## LUC60422975-A & WAT60422976-A Request for Further Information under Section 92(1) of the RMA

WSP has received the Section 92 RMA Request for Further Information (RFI) on December 20<sup>th</sup>, 2023. Each of the 9 questions included within the RFI have been outlined in table below and are responded to accordingly.

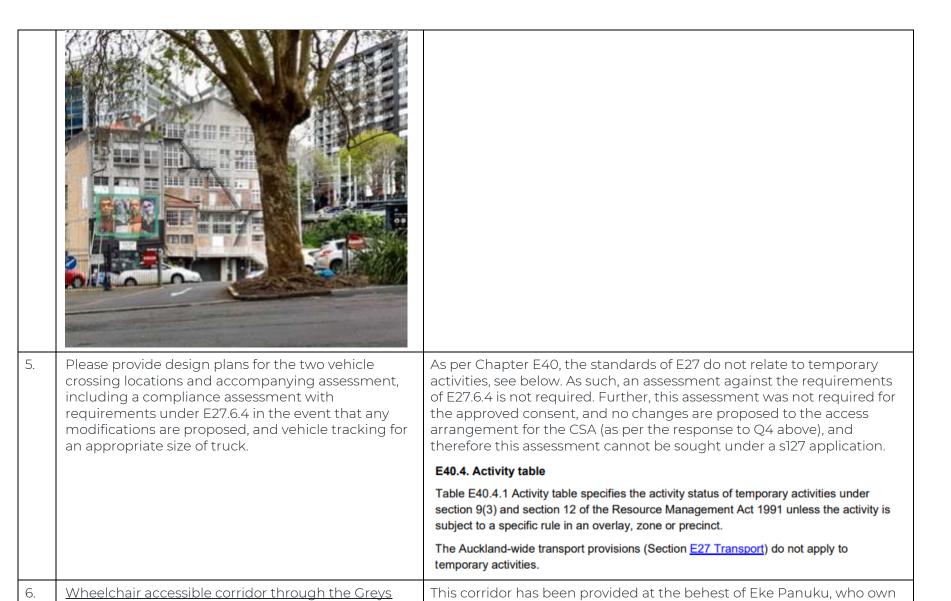
3. We note that the Andy OSullivan reports (dated 25 and 29 March 2024) in Appendix C - "Mechanical Settlement Analysis" in the WSP report titled "Assessment of Dewatering Effects" are unchanged from the previous version of the WSP report.

Please confirm why no changes to these reports have been undertaken given the proposed changes to the three shafts

A letter has been prepared by Andy O'Sullivan to address this matter, see **Attachment B**.

In summary, there is no increase to the predicted mechanical settlement behind the temporary retention from the changes in the plan layout of the proposed shafts due to the adoption of a stiffer temporary retention for the proposed shafts.

The mechanical settlement of the new temporary works design is not expected to increase from the previous assessment, so adopting the previous assessment is considered appropriate. This is consistent with the approach taken for updating the dewatering assessment.
